ADDENDUM 1
RFB #17-0038
RONALD REAGAN BUILDING RENOVATION-FLOORS 4,5,6

**RONALD REAGAN BUILDING RENOVATION – FLOORS
4,5,6
Sedgwick County**

Prepared by:
Schaefer Johnson Cox Frey Architecture, Inc.

COVER

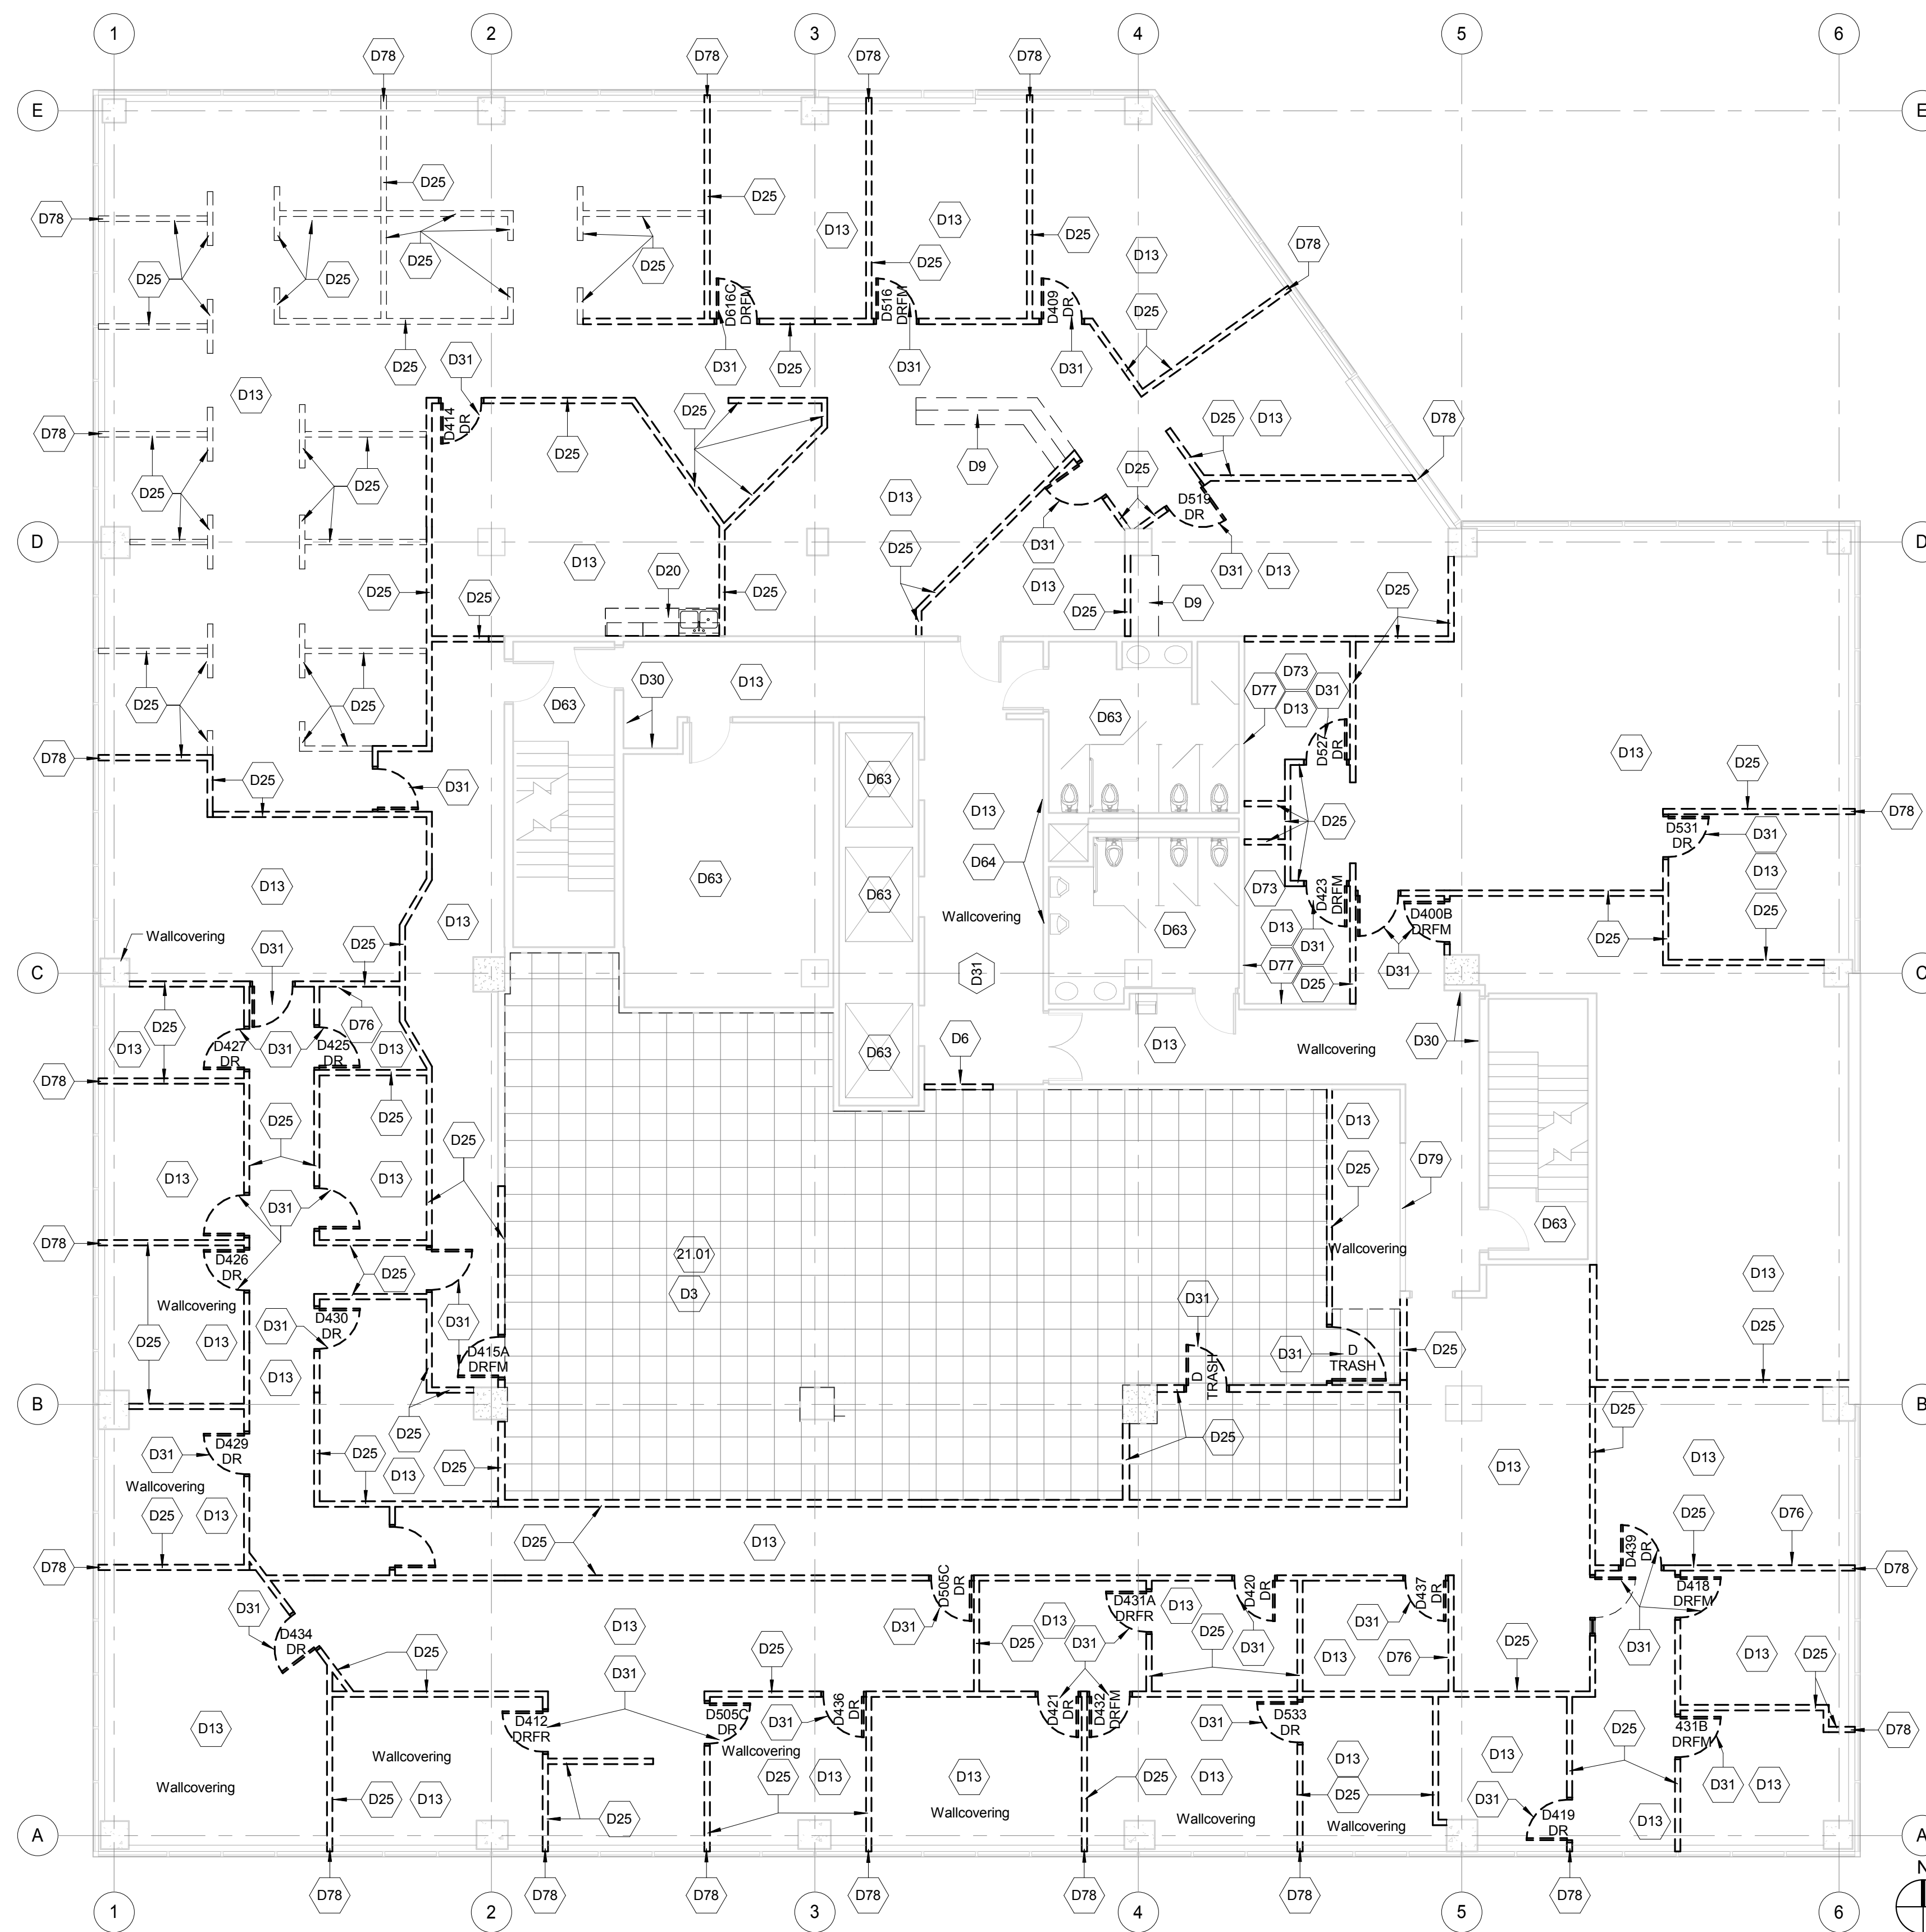
ITEM AD1-A01 DRAWING SHEET, COVER:
REVISION Under Project Certification, revise "2010 Uniform Plumbing Code" to read "2015 Uniform Plumbing Code" per attached.

- 35 **ITEM AD1-A14** DRAWING SHEET COVER, GENERAL NOTES:
REVISION In the first general note, the Contractor shall verify all fire extinguisher
locations prior to demolition. Reinstall fire extinguishers / cabinets as
needed so that travel distance does not exceed 75' from any point in the
building to nearest fire extinguisher. Contractor shall include one
additional type 2A 10BC fire extinguisher on wall bracket for room 514.

Project Number	5278.05
Date	08 MARCH 2017
4TH FLOOR DEMOLITION PLAN

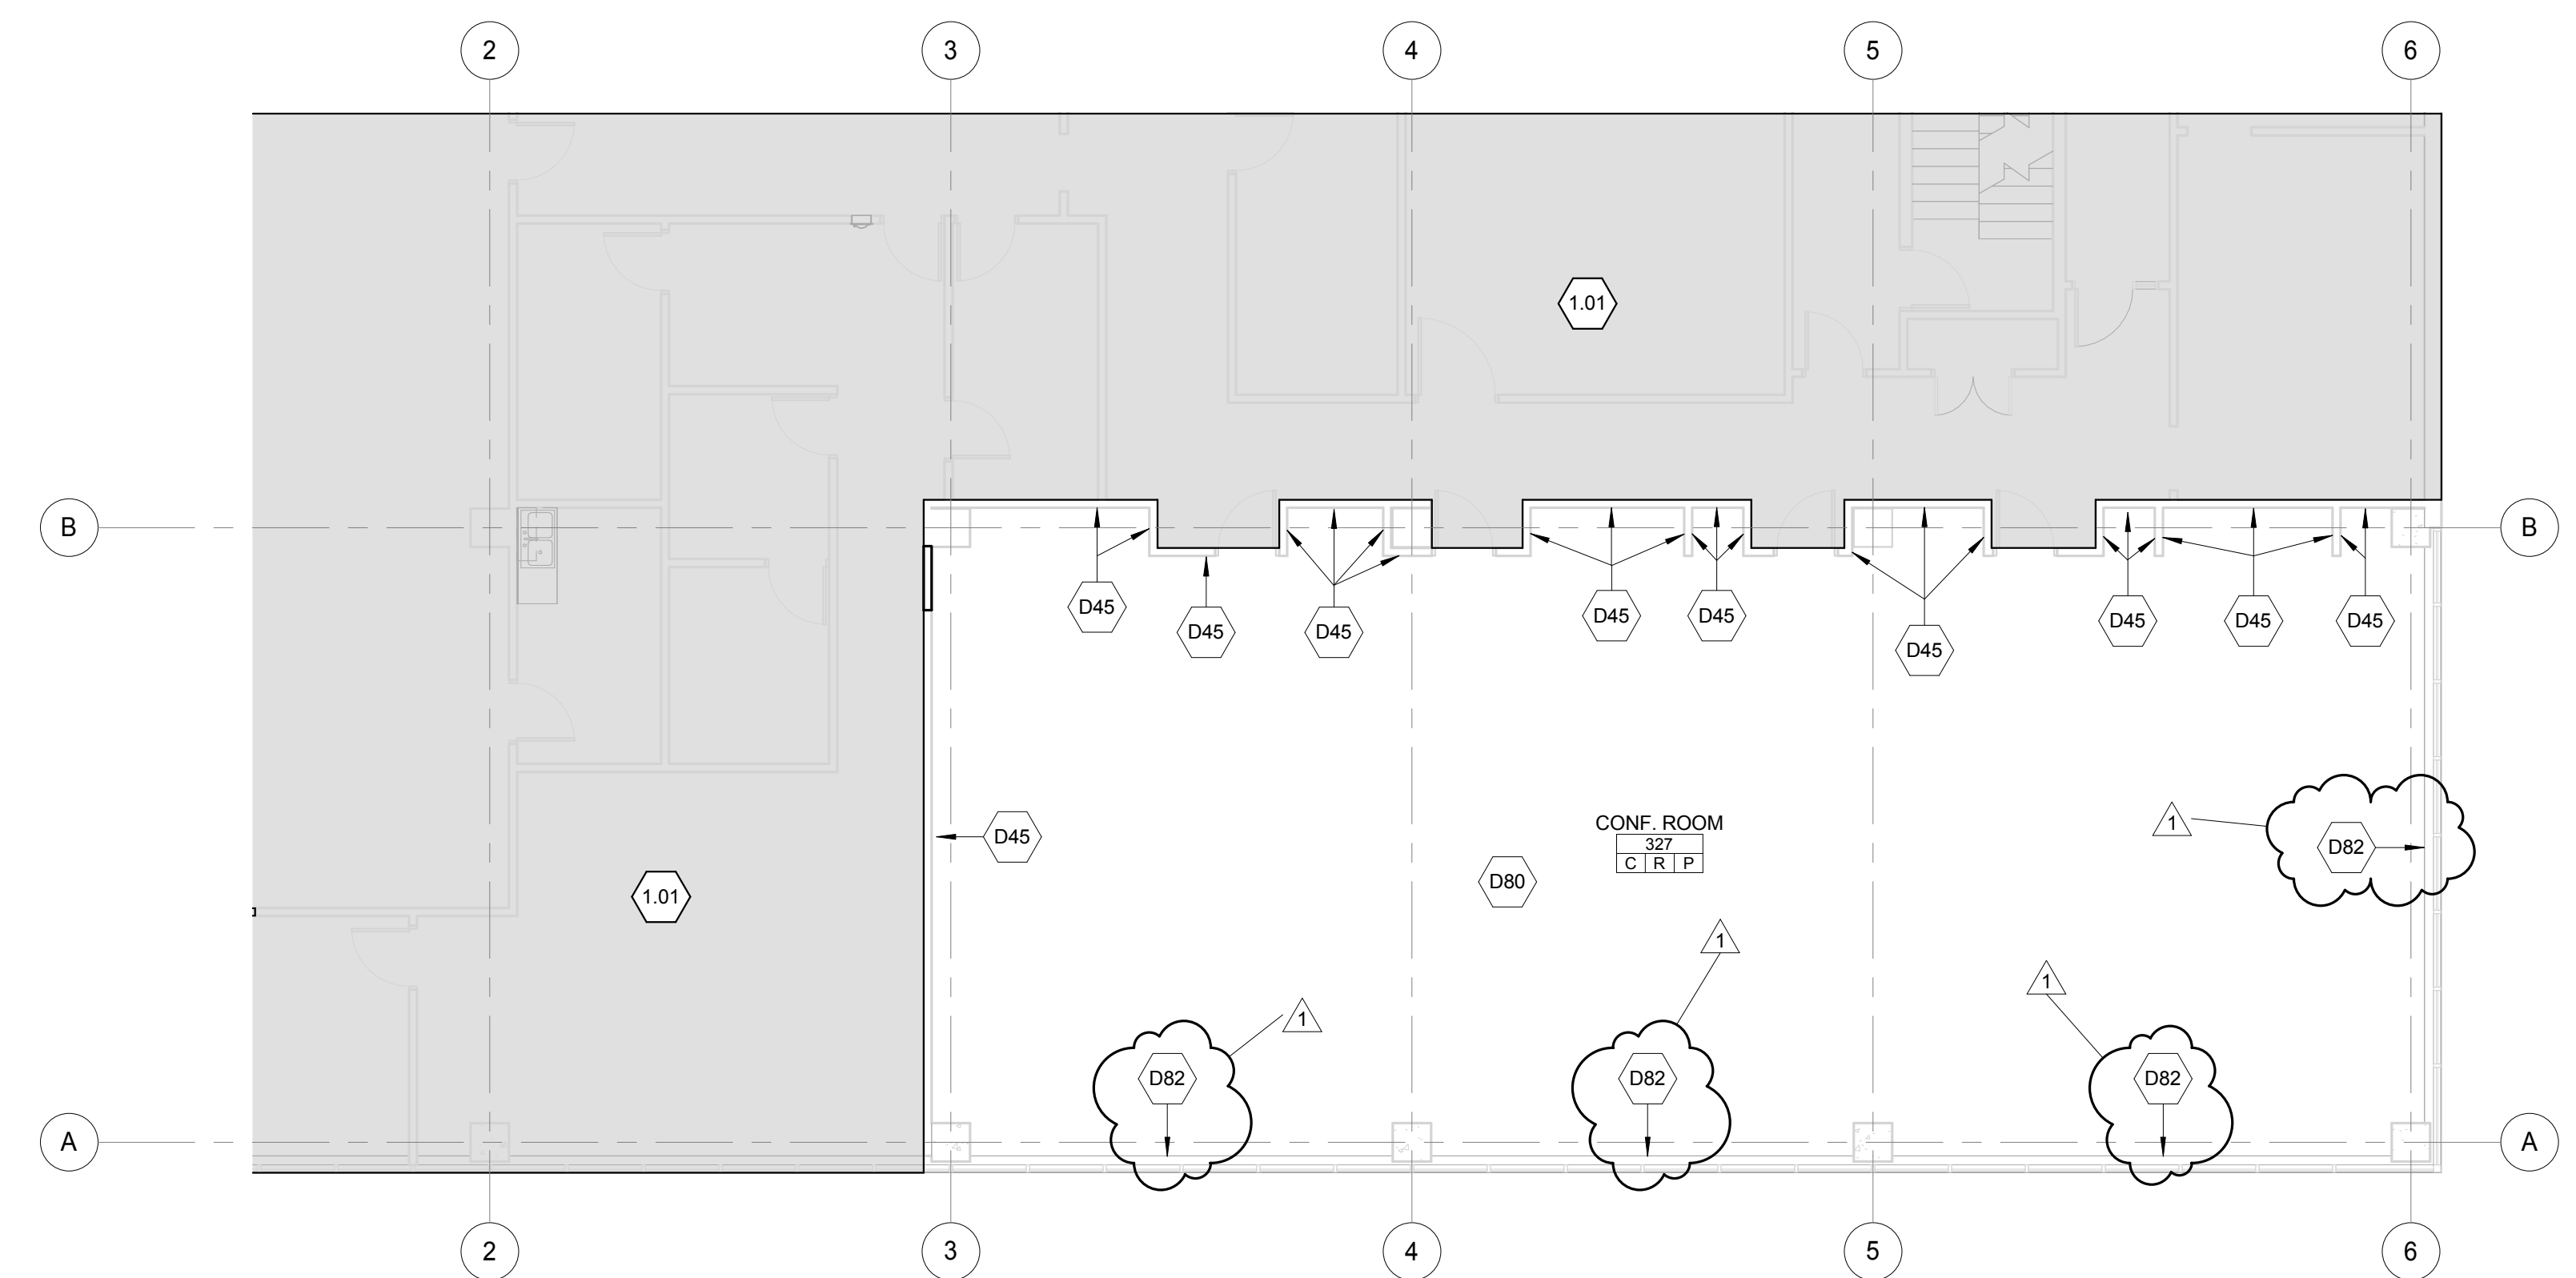
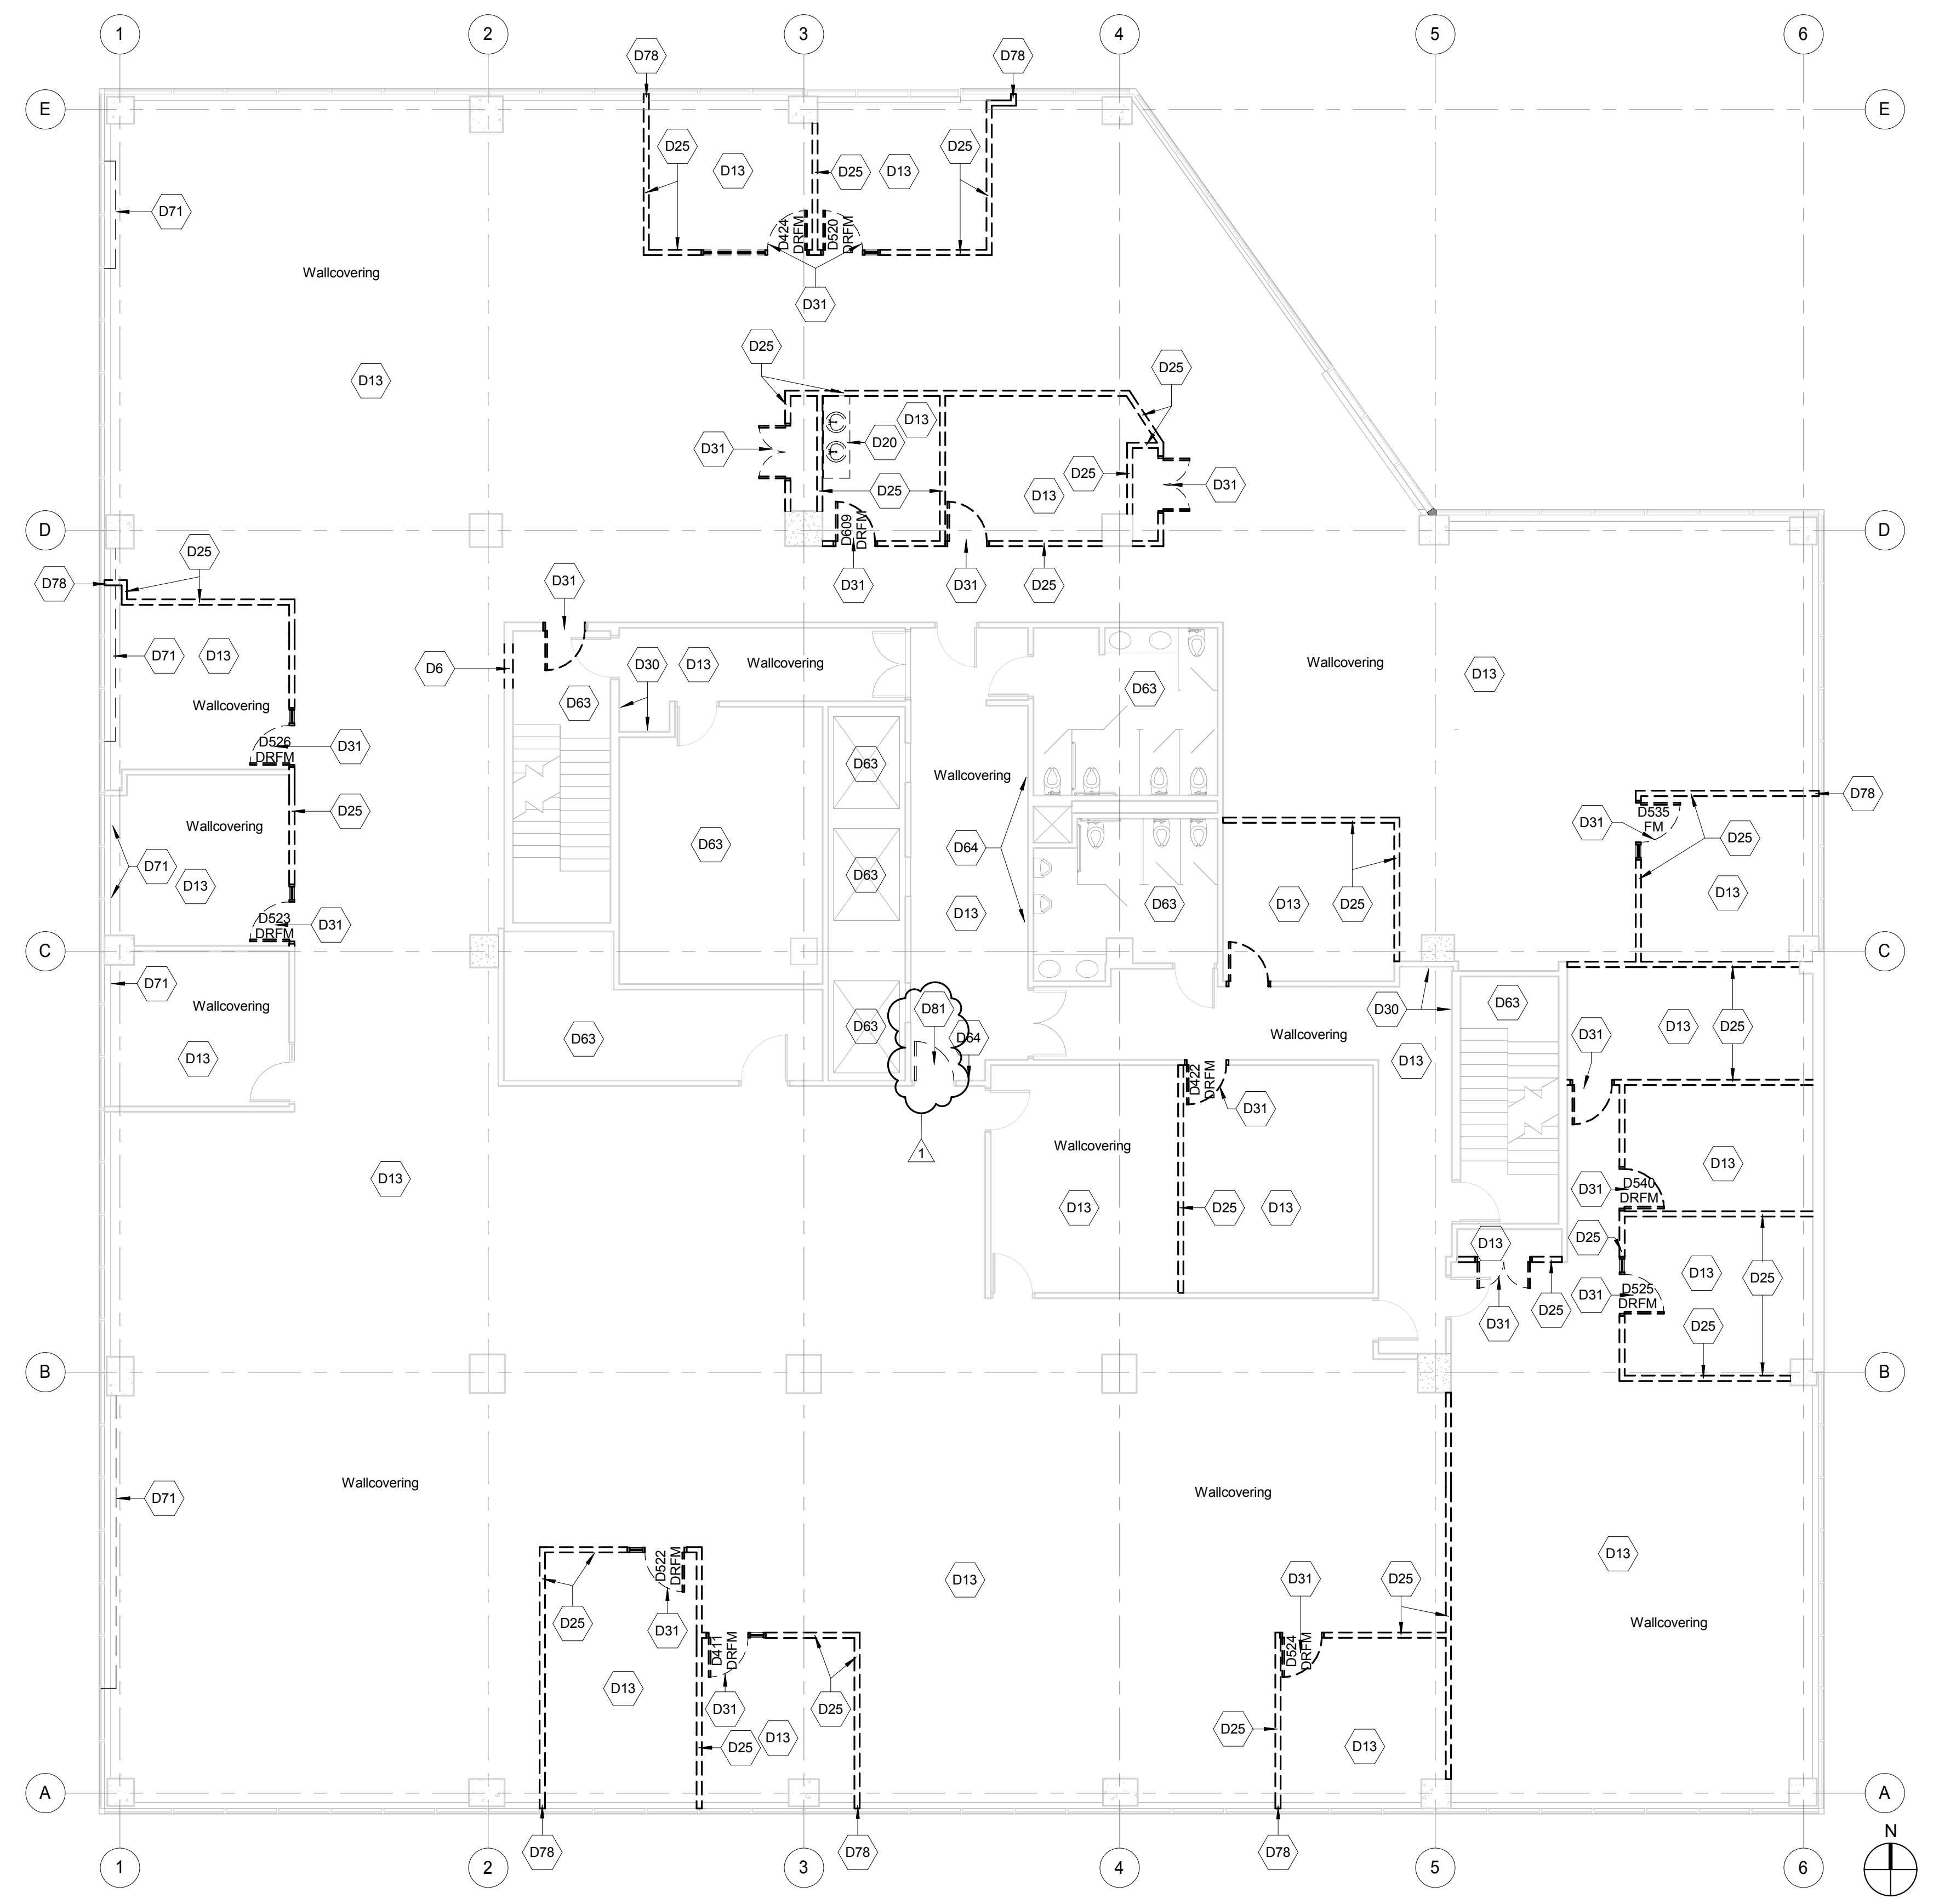
ITEM AD1-A02 DRAWING SHEET A21.1, KEYED NOTES:
REVISION Add keyed note D82 to keyed notes list and Level 3 Demo Plan per attached.

- 45 **ITEM AD1-A16** DRAWING SHEET A21.1, KEYED NOTES:
CLARIFICATION Keyed Note 21.01: The fire suppressions system located beneath the
raised flooring is a wet system.

- 50 **ITEM AD1-A17** DRAWING SHEET A21.1, KEYED NOTES:
DELETION Keyed Note 8.17: Delete this keyed note.
- 55 **ITEM AD1-A18** DRAWING SHEET A22.2, KEYED NOTES:
REVISION Keyed Note 11.21: Revise to read "Mobile filing system and plywood infill
by Owner. Contractor to provide carpet tile over plywood between tracks."
